Project	COUNTRY FLATS, SANDFIELDS
Project number	N297
Client	HALE CONSTRUCTION LTD
Title	BLOCK 01/02 ELEVATIONS 1/2
Drawing number	A011
Scale	1 : 100 at A1
Revision	H
Status	INFORMATION
Drawn	PC
Date	30.11.21

DESIGN CHANGES

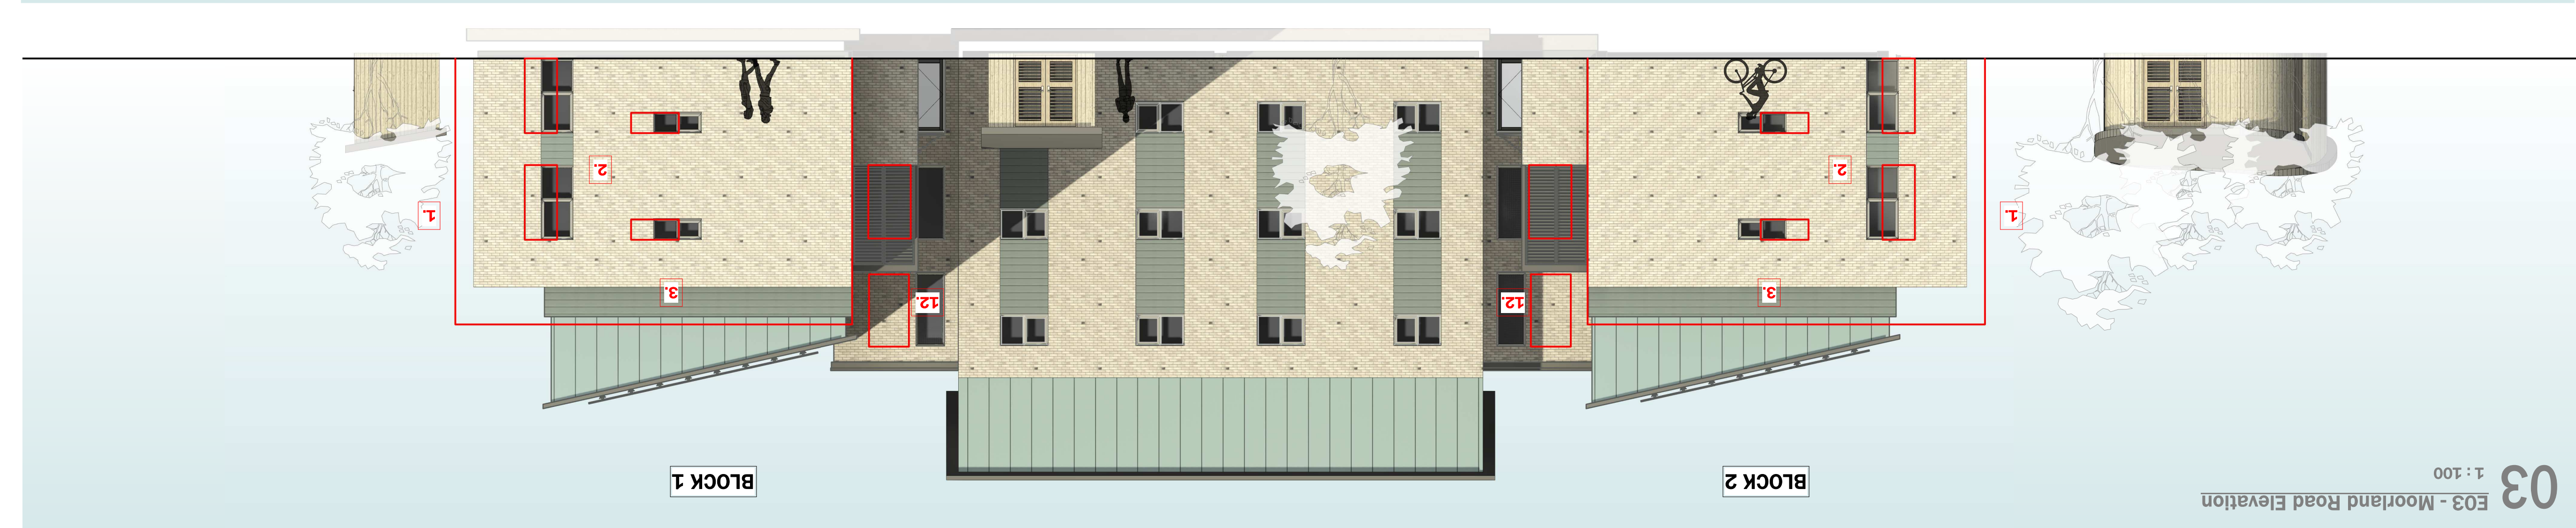
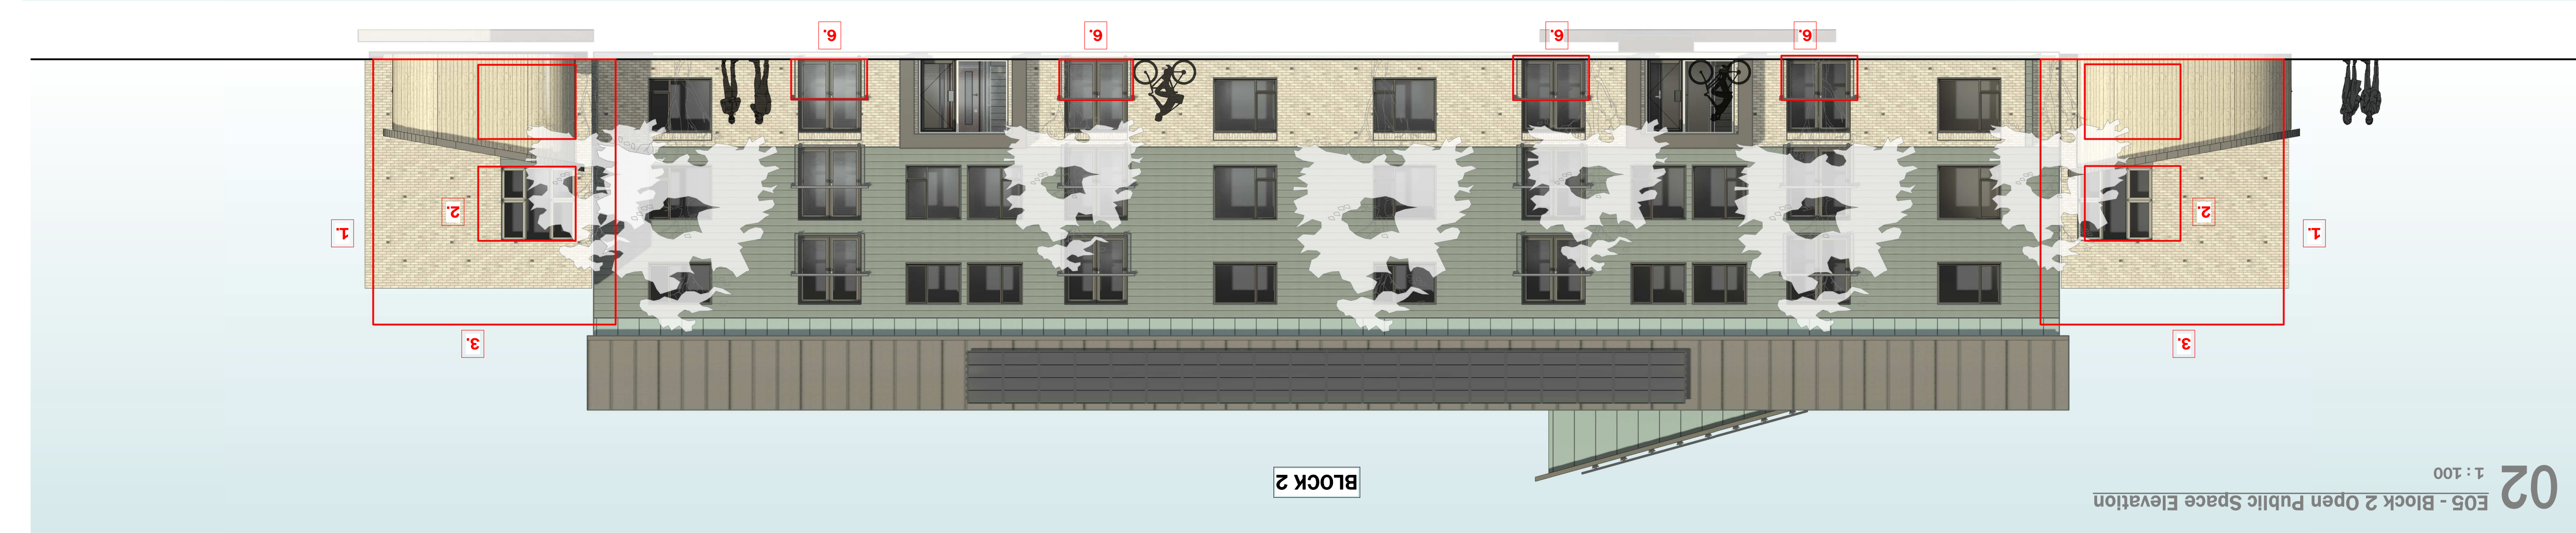
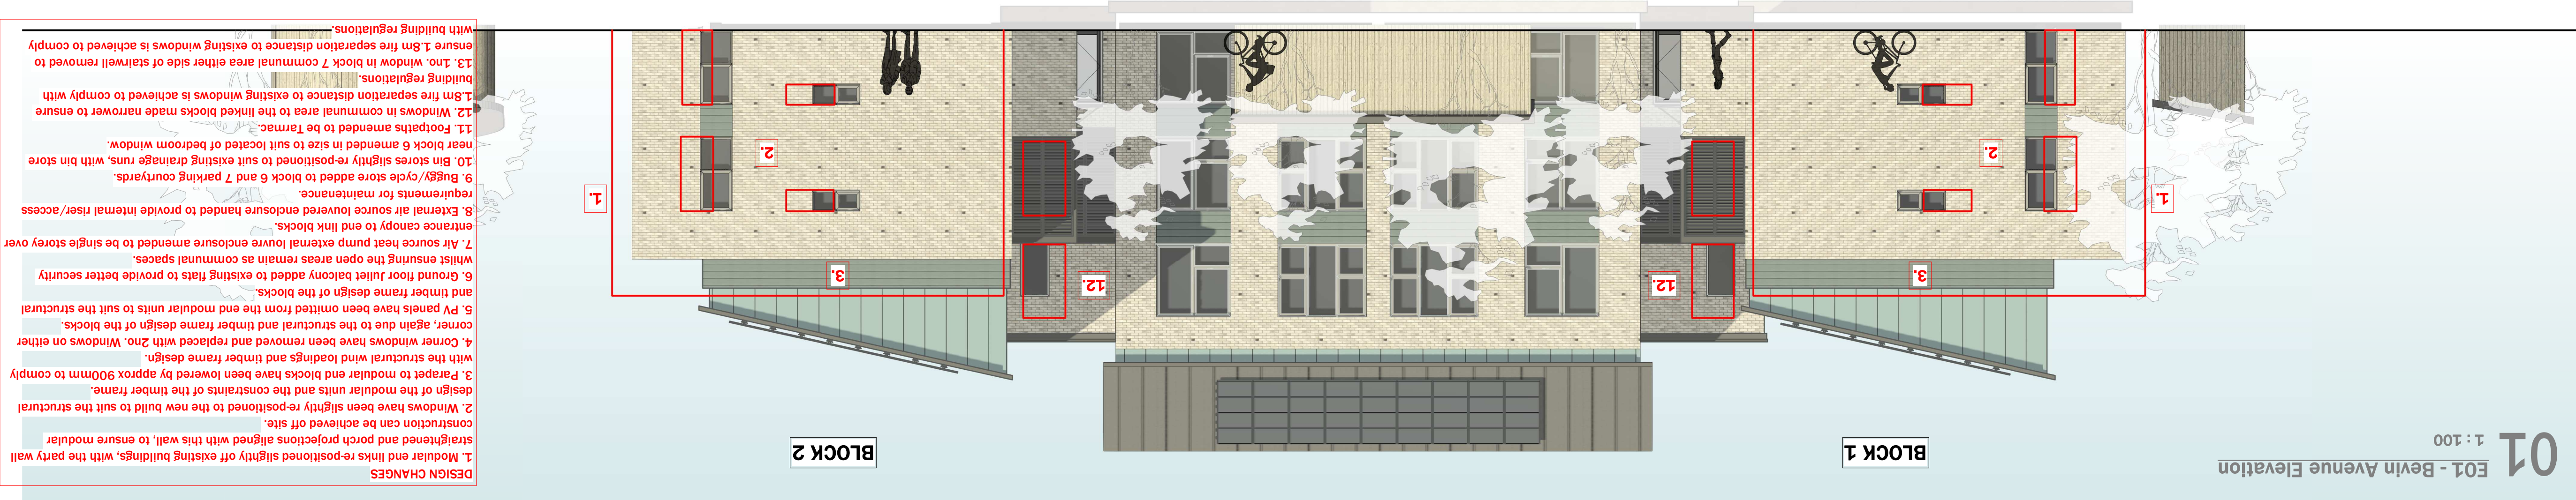
1. Modular end links re-positioned slightly off existing buildings, with the party wall strengthened and porch projections aligned with this wall, to ensure modular construction can be achieved off site.

2. Windows have been slightly re-positioned to the new build to suit the structural design of the modular units and the constraints of the timber frame.

3. Rampet to modular and blocks have been lowered by approx 500mm to comply with the structural wind loadings and timber frame design.

4. Corner windows have been removed and replaced with 2no. Windows on either corner, again due to the structural and timber frame design of the blocks.

5. PV panels have been omitted from the end modular units to suit the structural and timber frame design of the blocks.

6. Ground floor Juliet balcony added to existing flats to provide better security whilst ensuring the open areas remain as communal spaces.

7. Air source heat pump external louvre enclosure amended to be single storey over entrance canopy to end link blocks.

8. External air source lowered enclosure handed to provide internal riser/access requirements for maintenance.

12. Windows in communal area to the linked blocks made narrower to comply with 1.8m fire separation distance to existing buildings.
